RE: TEDS Exception No. 36-03, to Access Spacing at 3134 D ½ Road

DESIGN EXCEPTION #DE36-03

RE: Exception from Access Spacing for 3134 D ½ Road (Summit Meadows West)

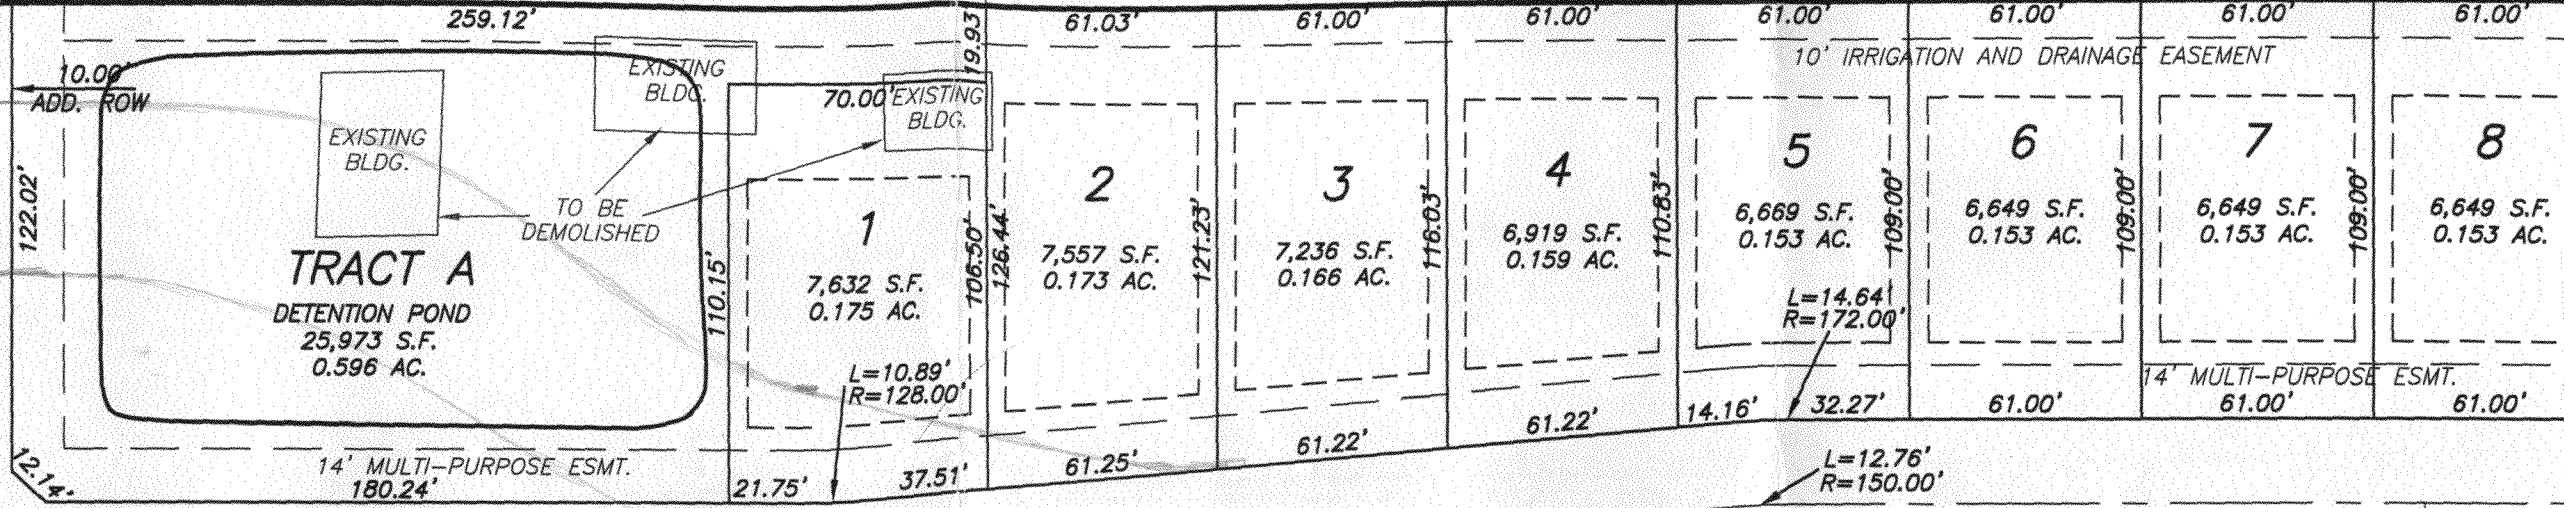
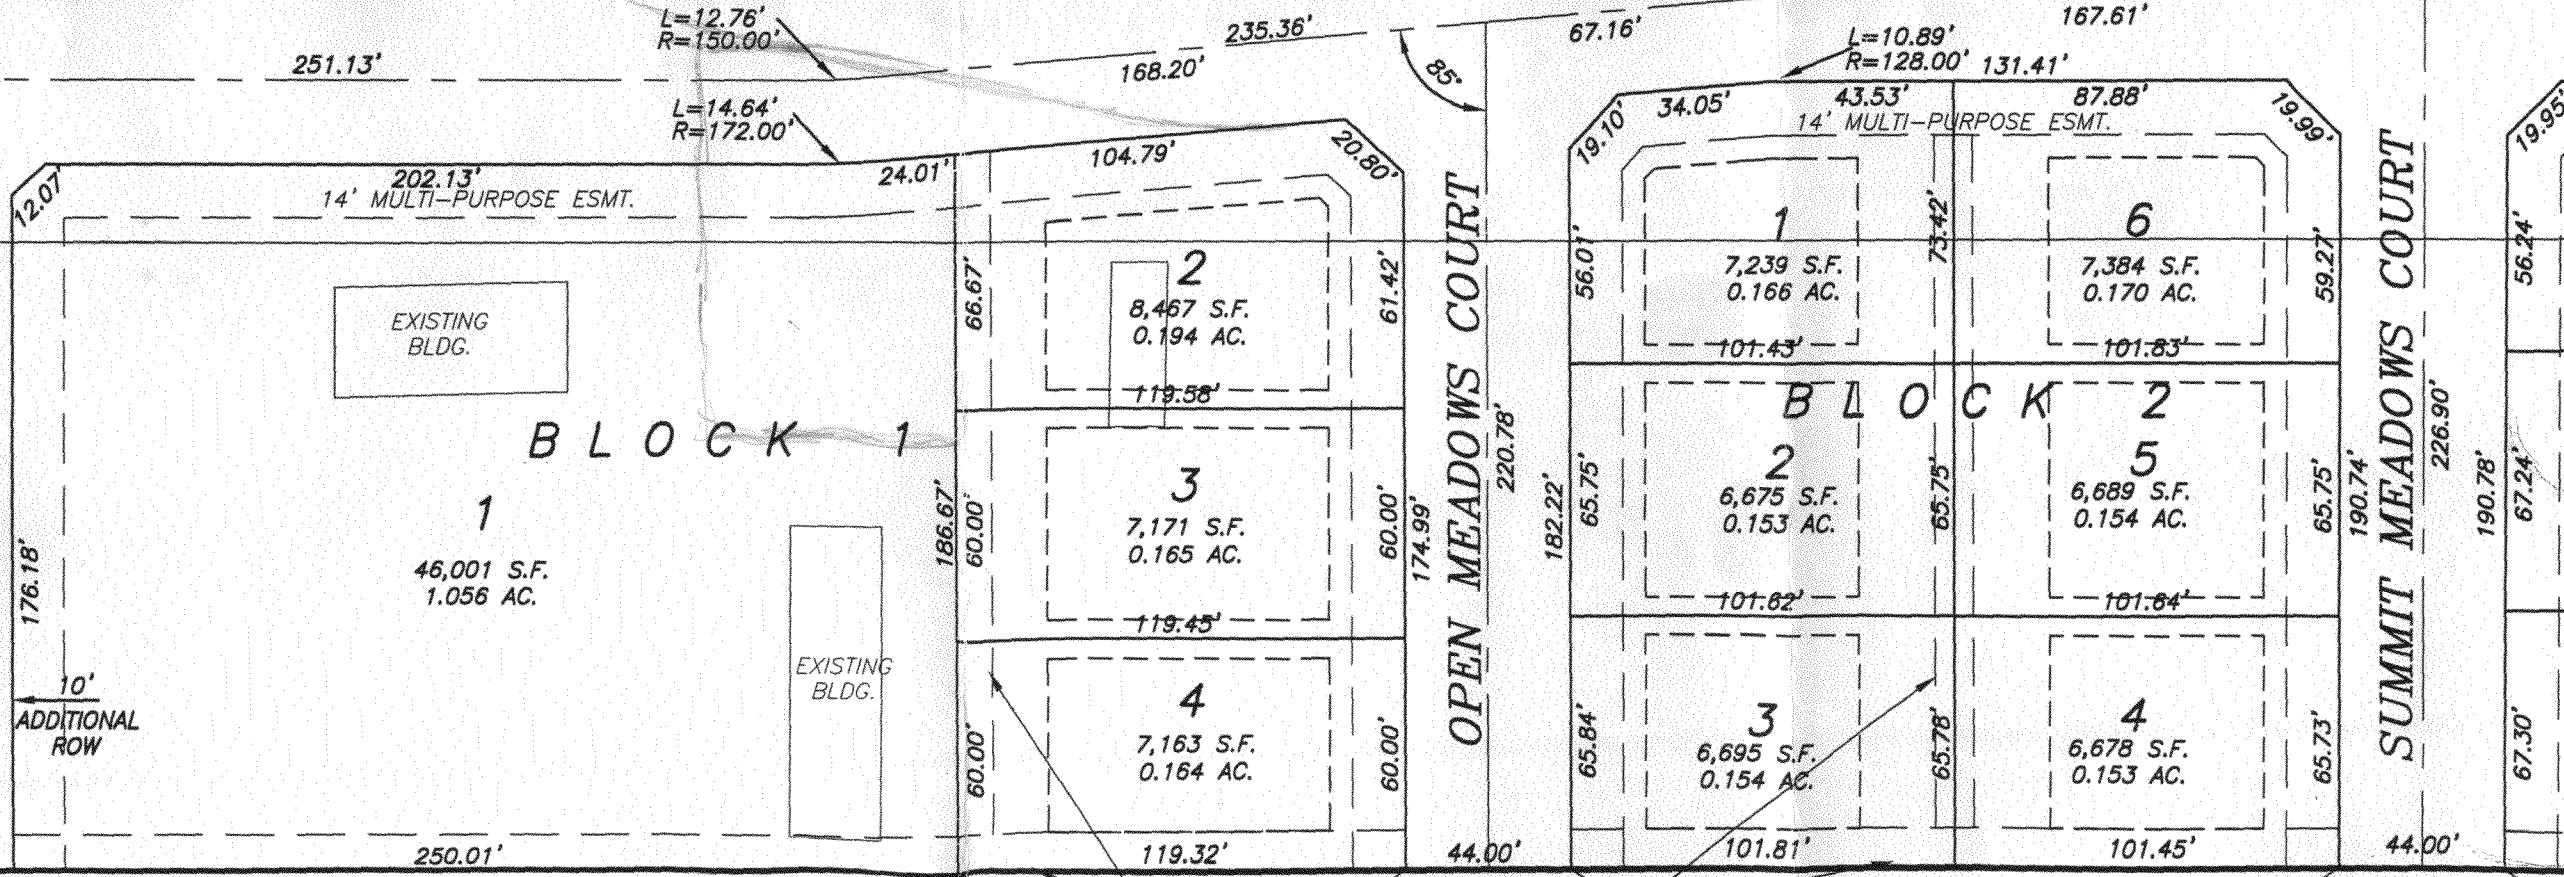
Two single-family driveway accesses exist south of the proposed Summit Meadows West subdivision (south side of D.5 Road). The easternmost driveway (3139 D.5 Road) is offset from Larry's Meadow Drive by approximately 135 feet. The west driveway (3137 D.5 Road) is offset from Larry's Meadow Drive by approximately 25 feet. The TEDS exception proposed is to waive the offset distance requirement for the west driveway (25 feet offset).

No alternative exists for aligning Larry's Meadow Drive with the easternmost driveway south of D.5 Road. That alternative creates an offset with Clear Creek Drive of about 80 feet. The alternative of aligning Larry's Meadow Drive with the west driveway south of D.5 Road provided lots on the west that were adequate in depth but created a lot for the parent parcel owners that was larger than they preferred, hence the alignment was shifted some 25 feet east to satisfy the sale of the property and the layout of proposed Summit Meadows West subdivision.
